# CITY OF ALBUQUERQUE

RE: **Lot 10 Block 9 Rebonito Subdivision**  
**1625 Valdez Dr. NE**  
**Grading and Drainage Plan**  
**Engineers Stamp Date 10/27/2021 (J23D031)**  
**Pad Certification Date 12/20/2021**

## DRAINAGE AND TRANSPORTATION INFORMATION SHEET (REV 6/2018)

ENGINEER'S SEAL  10/27/21 DAVID SOULE P.E. #14522	1625 VALDEZ	DRAWN BY: WCVJ
	GRADING AND DRAINAGE PLAN	DATE: 8-06-21
 1606 CENTRAL AVENUE SE SUITE 201 ALBUQUERQUE, NM 87106 (505) 872-5999		210210082-LAYOUT-8-27-21
		SHEET #
		JOB # 21021082

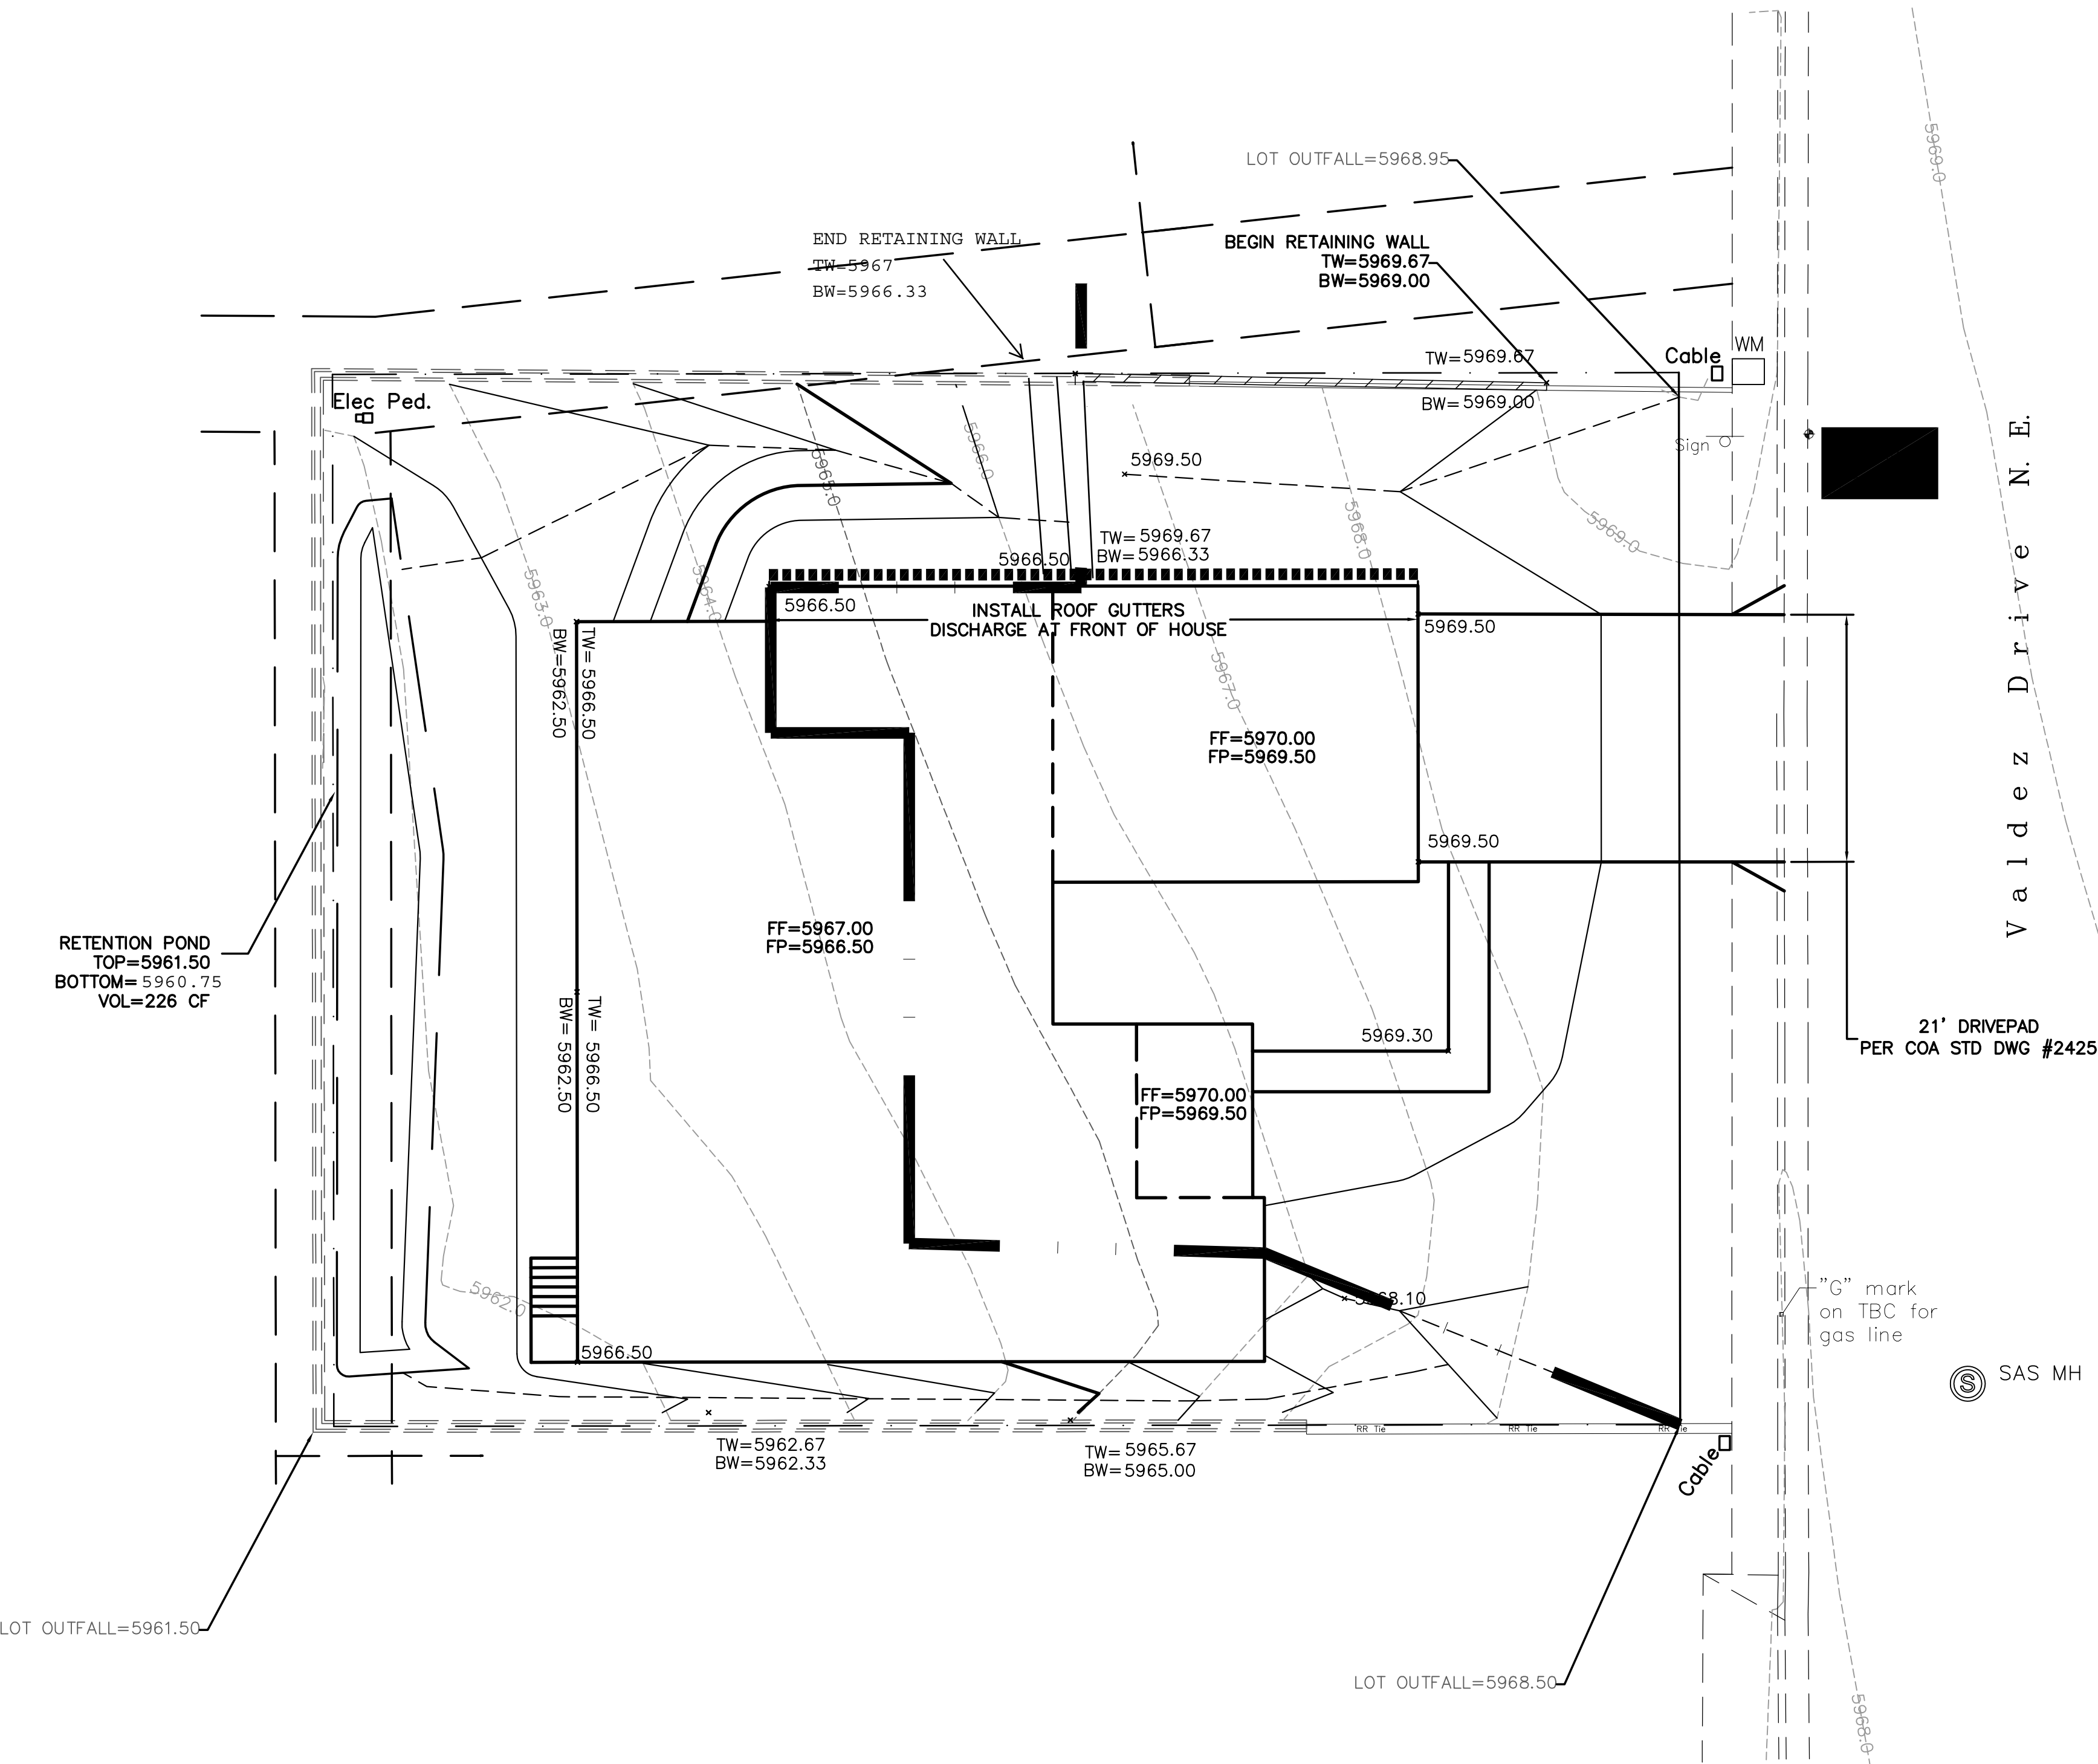
Based upon the information provided in your submittal received 1/3/2022, this plan is approved for Building Permit.

Albuquerque **Reiterate to the Owner/Contractor that a separate permit for a garden/retaining wall must be obtained, with the approved G&D plan. Also, advise the owner/contractor not to use dirt as a ramp to climb the curb. If dirt is used it will cause a delay in permitting.**

NM 87103 Prior to Certificate of Occupancy release, Engineer Certification per the DPM checklist of this plan will be required.
